**RE: Request for Information (RFI) Pursuant to Section 308 of the Clean Water Act
Garlock Sealing Technologies (NY0000078)
Docket No. CWA-IR-15-023**

Compliance Evaluation Inspection: Garlock Sealing Technologies	
Inspection Date: February 27, 2015 Inspection Time: 9:00 AM – 1:45 PM	
EPA Inspector: Katherine Mann, Physical Scientist, USEPA Region 2, DECA, Water Compliance Branch, (212) 637-4226	
NYSDEC Representative: Nancy Rice, Environmental Engineer 1, Division of Water, NYSDEC Region 8, (585) 266-5453	
Site Representatives: David Samsonik, Manufacturing Supervisor, (315) 597-3057; Larry VanHoesen, Wastewater Operator, (315) 597-3392; Pete Orlando, Facilities Specialist; Carrie SanAngelo, EHS; Marc Rosen, Manufacturing Engineer	
Site Information: Garlock Sealing Technologies 1666 Division Street Palmyra, NY 14522 SPDES No. NY0000078	
Owner/Operator: Garlock Sealing Technologies, LLC 1666 Division Street Palmyra, NY 14522

P2270025

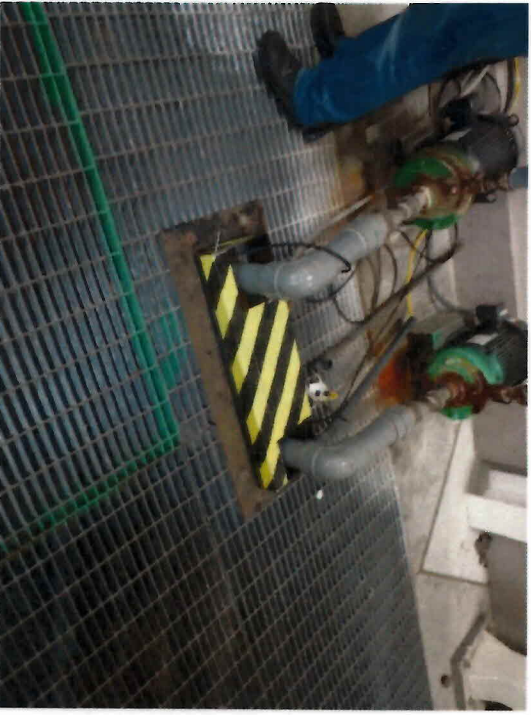
5. As identified in photograph P2270025, uncovered dumpsters for rubber and trash collection were identified on the east side of the Facility. Although no catch basins were observed in the immediate downstream vicinity of the dumpsters at the time of the CEI, catch basin in the parking lot near the dumpsters drain to Outfall 017. Dumpsters containing waste materials such as rubber and trash should be covered in order to prevent exposure to stormwater and the transport of pollutants to surface water bodies.
